Charlotte-Mecklenburg Planning, Design, & Development

SUBJECT: Administrative Approval for Petition No. 2016-032 NR Pinehurst Property Owner, LLC

PINEHURST MULTIFAMILY REZONING
 4100 PROVIDENCE ROAD
 CHARLOTTE, NC 28204

CONDITIONAL REZONING PLAN

RZ-100

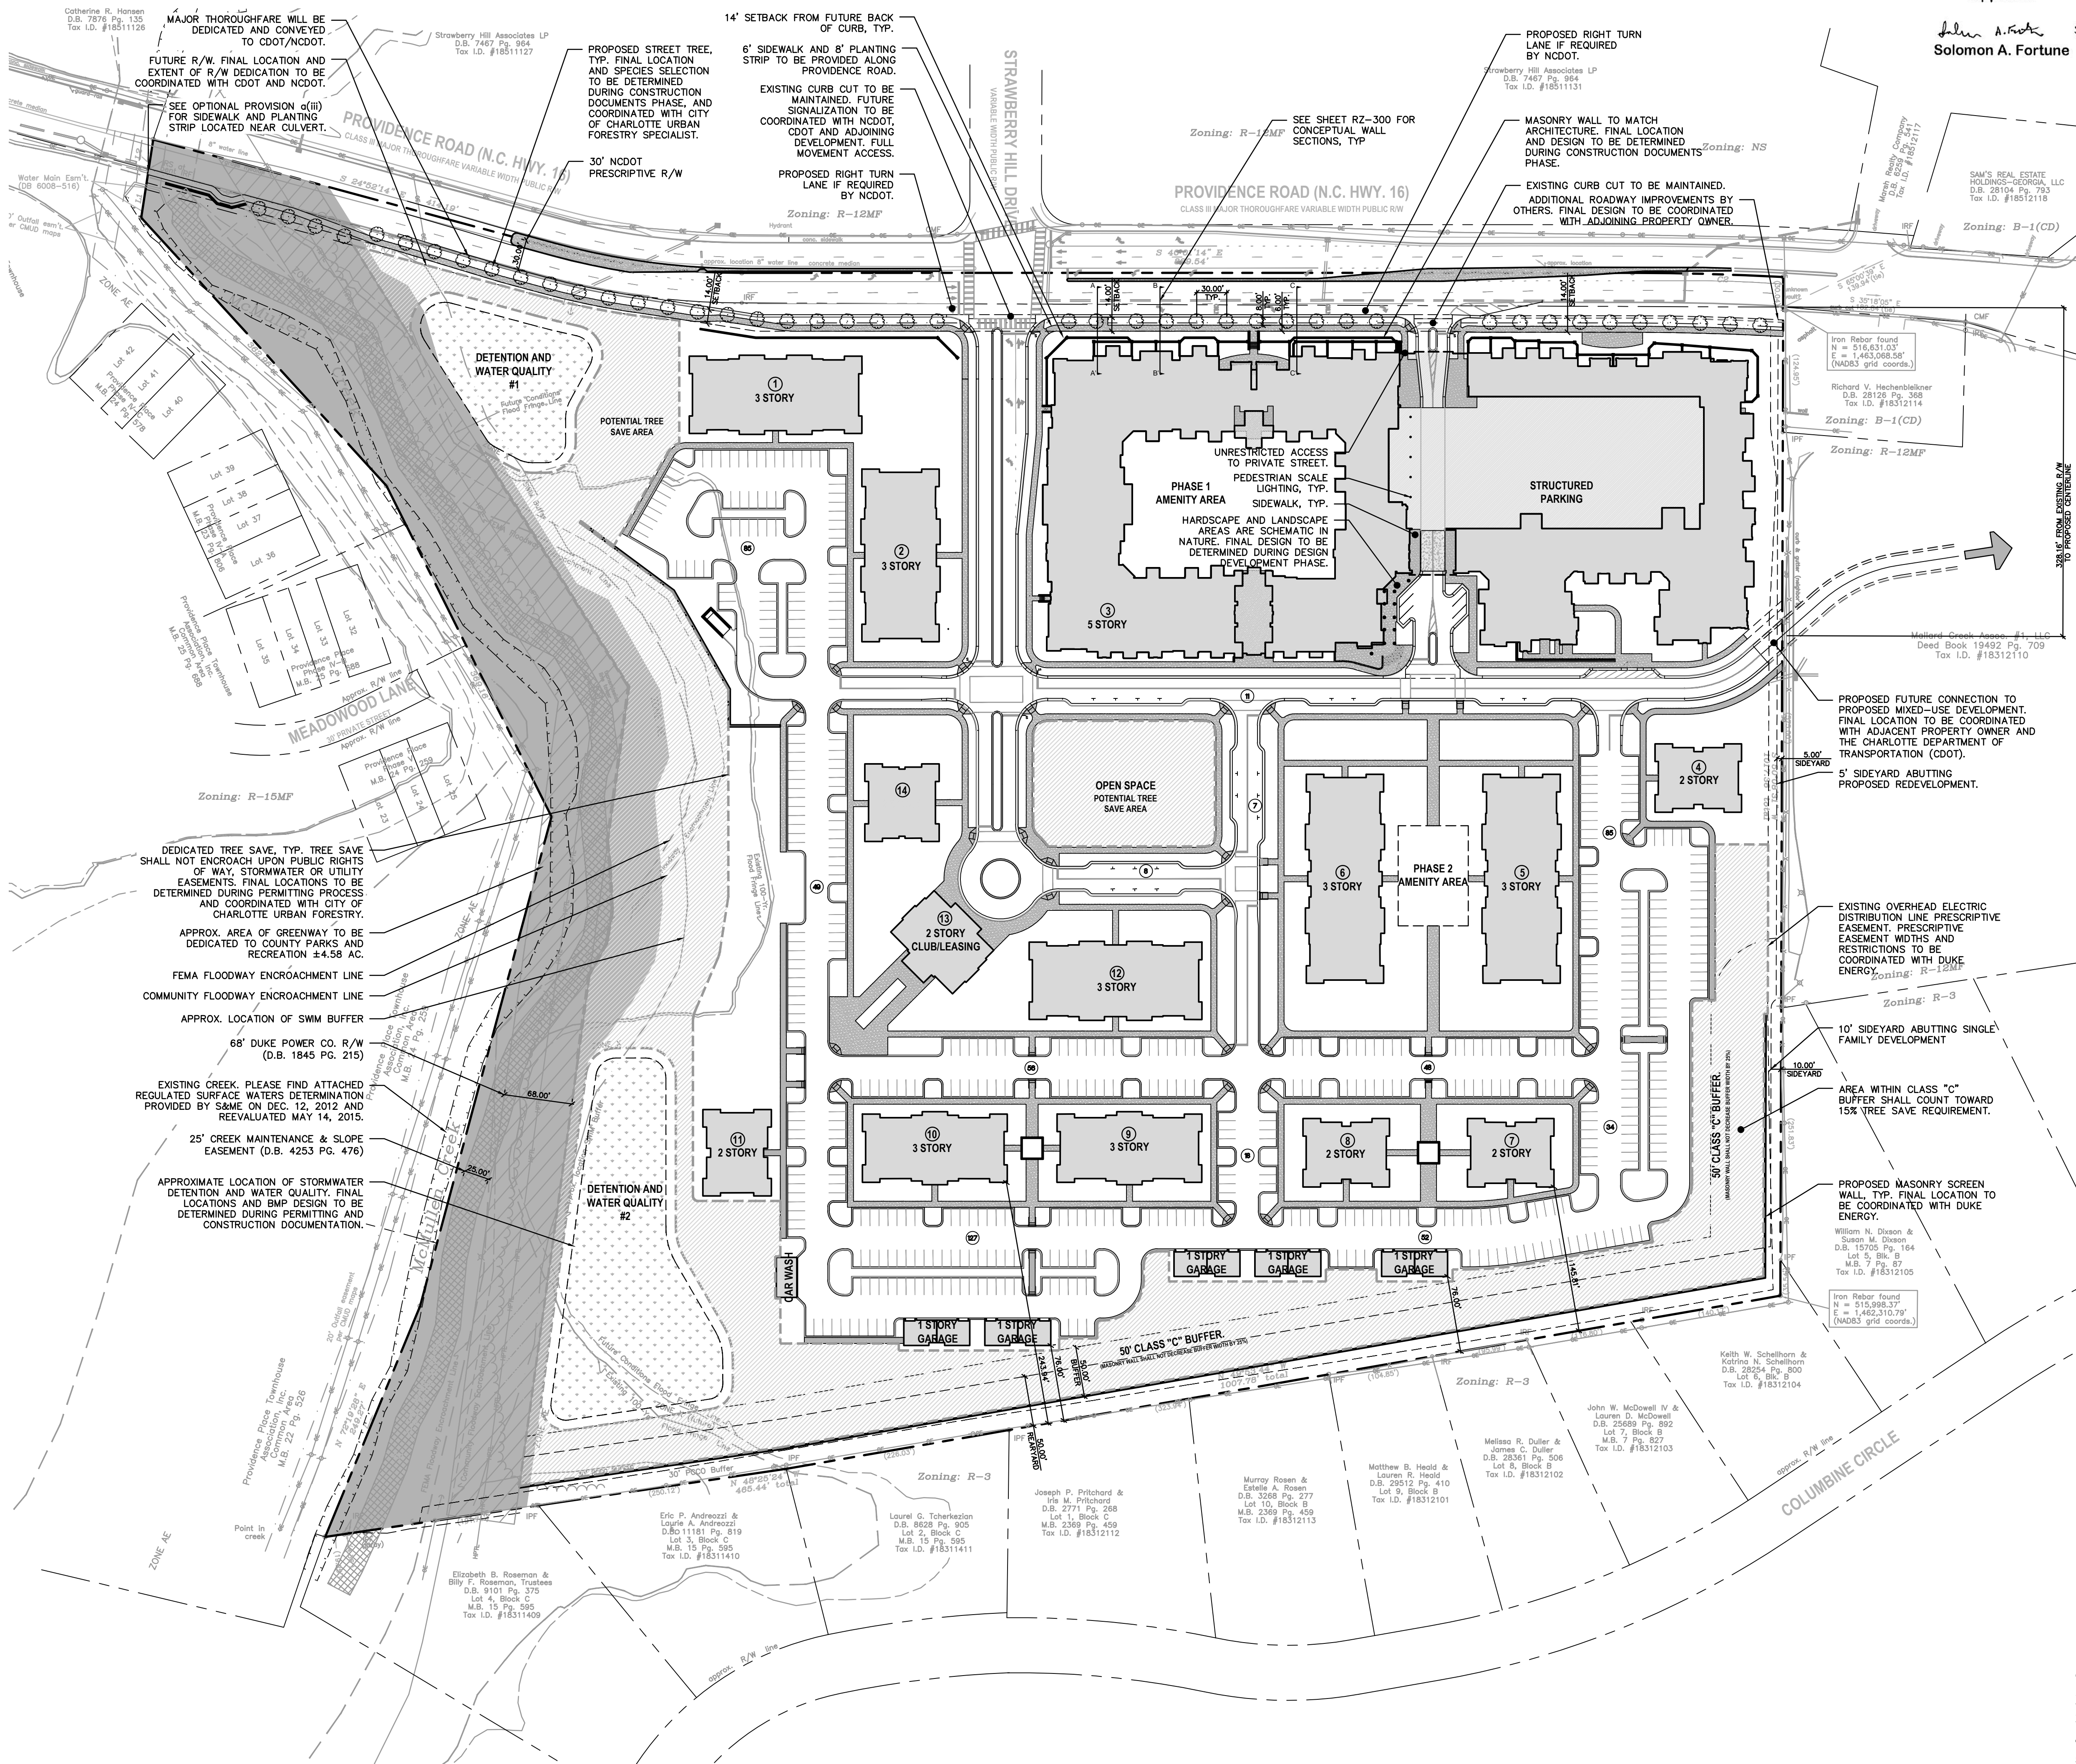
- Modification to the dedication of right-of-way to 327th C.O.

08/10/18 - REQUEST FOR ADMINISTRATIVE AMENDMENT

b.Petitioner will dedicate in fee-simple to the City of Charlotte that portion of the Site's frontage on Providence Road that is more particularly depicted on the Rezoning Plan as right-of-way. This right-of-way dedication will occur prior to the issuance of the 327th certificate of occupancy for the first new building completed on the Site.
